BLM SCALAR FIX -Based on findbhudda's original design:
<http://www.midibox.org/dokuwiki/doku.php?id=findbuddha>

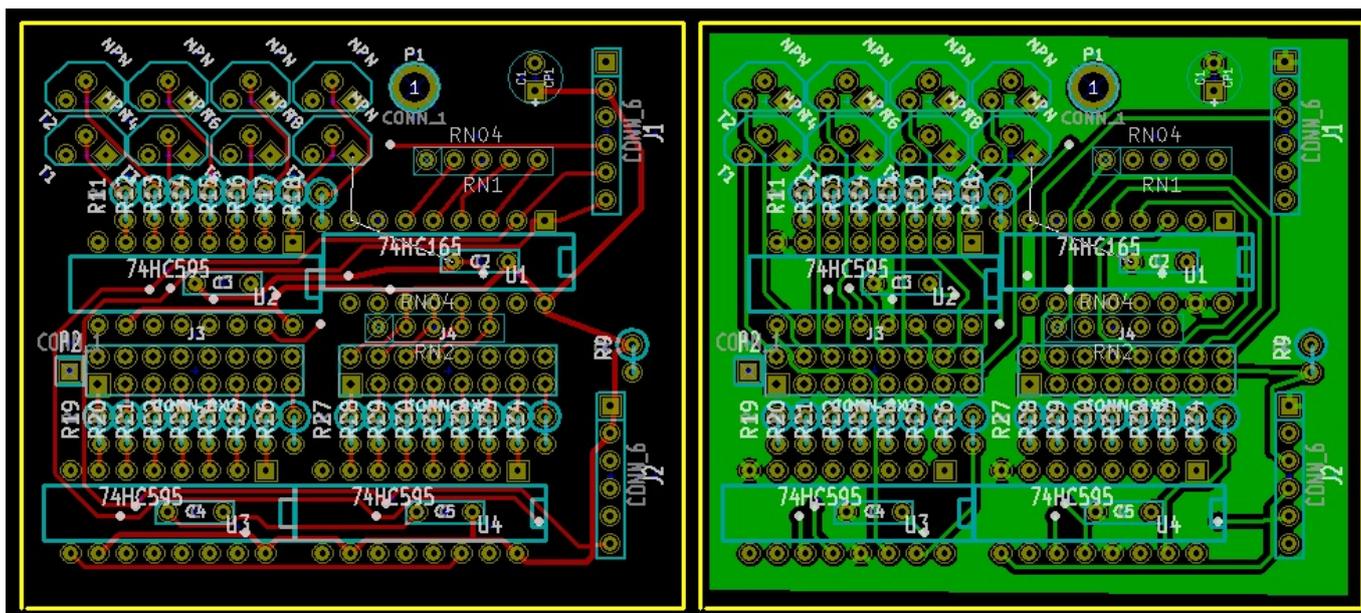
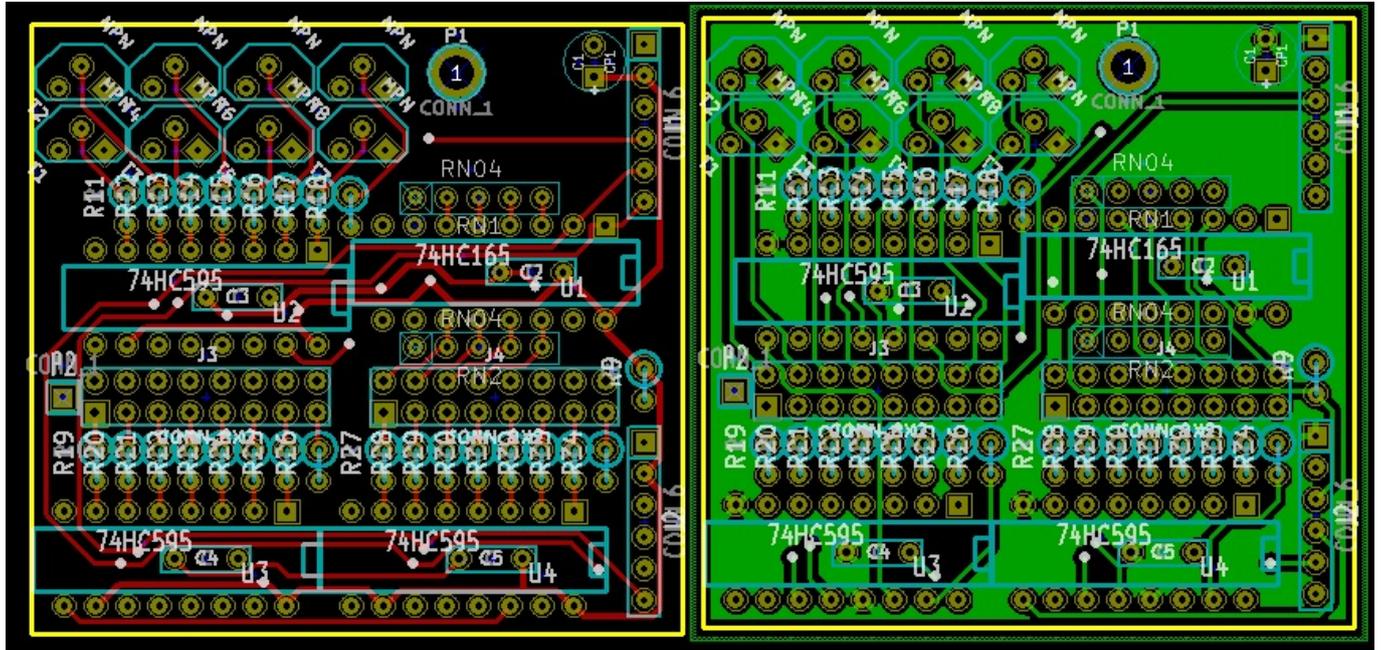
- blm-scalar.* contain an error. Pins I4-I7 are mirrored. This is easily fixed with a connector modification, and the blm-scalar module seems to work as intended.
- blm-scalar v1.1 attempts to fix this error. Moved connectors J1, J2, Resistor Net 1 and R9 to make room for corrections.

Corrected blm-scalar v1.1.brd bellow & attached [blm-scalar_v1.1.brd.zip](#)
